SUBJECT: Transmittal of Revised Responses to AP1000 DSER Open Items

**AP1000 Design Certification Review
Draft Safety Evaluation Report Open Item Non-Proprietary Responses**

DSER Open Item Number: 14.2-1.f (Response Revision 1)

DSER Open Item Number: 15.2.7-1 Item 10 Revision 2

Figure 1 – IRWST / Containment Recirc Sketch

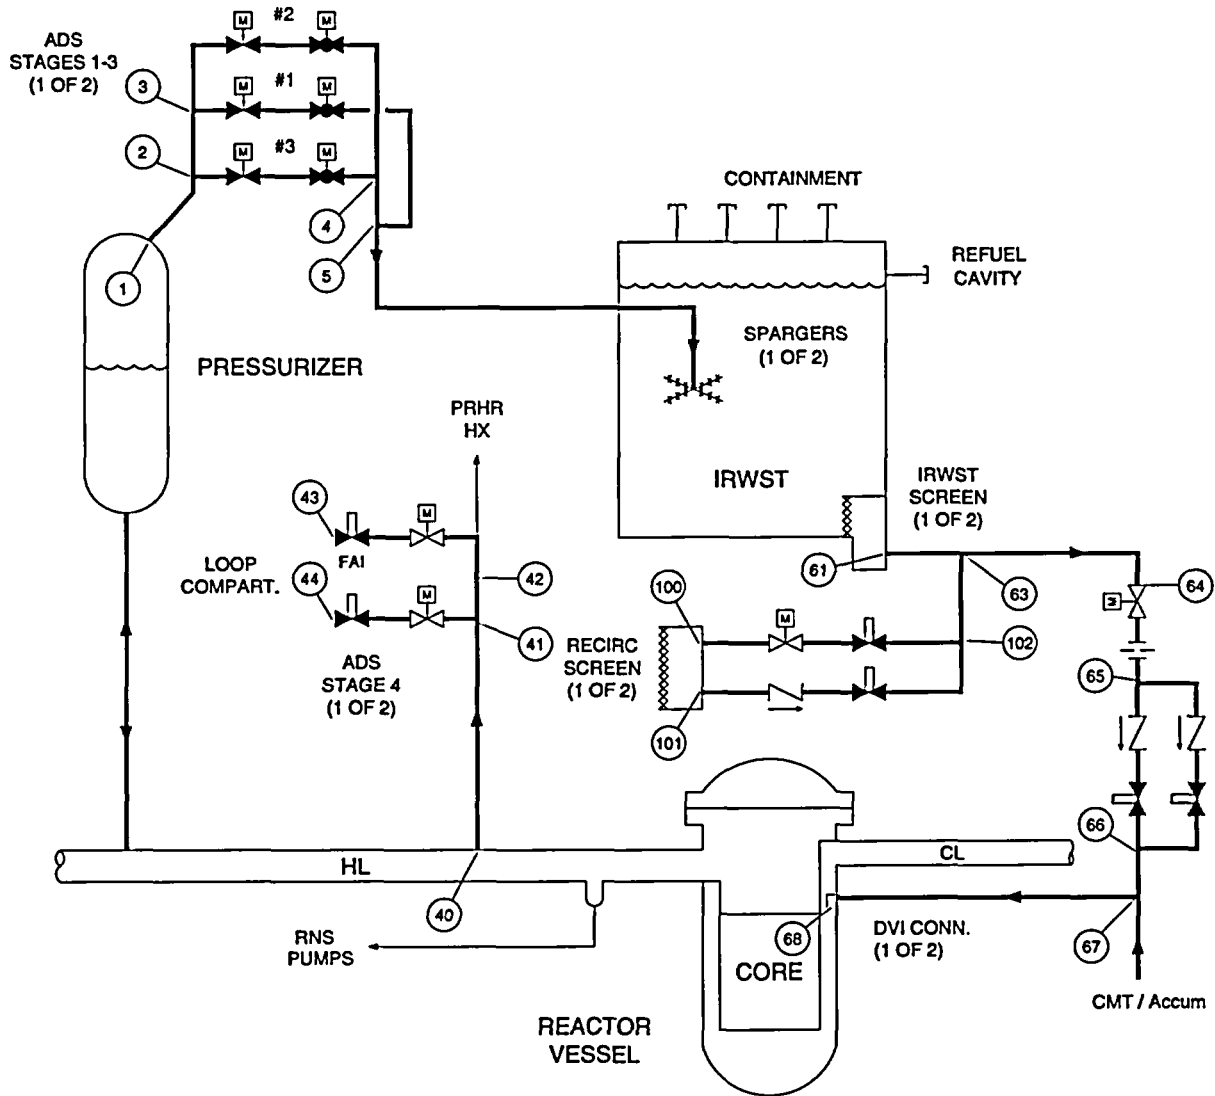
The NRC staff is attempting to modify the RELAP5 AP1000 model to evaluate LTC. The current model does not model sump recirculation into the DVI lines. Please provide the following information to enable the staff to perform LTC confirmatory analyses with RELAP5 for a postulated double DVI line break.

- A. Containment temperature, pressure, water level and boric acid concentration versus time for 30 days.
- B. Recirculation line lengths, areas, elevations and resistances. All elevations including containment water levels should be given relative to the reactor vessel DVI nozzle elevation.
- C. Recirculation valve actuation setpoints and the WCOBRA/TRAC calculated time for sump recirculation following a double ended DVI line break.
- D. Sump screen resistance as a function of flow blockage.

Revision 2 of this response is to change Figure 1 to show that the sump line MOV is normally open, and to add Figure 2 to show the DVI line relationship to the loop configuration more clearly.

- B. The IRWST recirc line flow resistances, inside diameters and volumes are listed in Table 1. Figure 1 shows a sketch of the PXS IRWST / Containment Recirc lines.
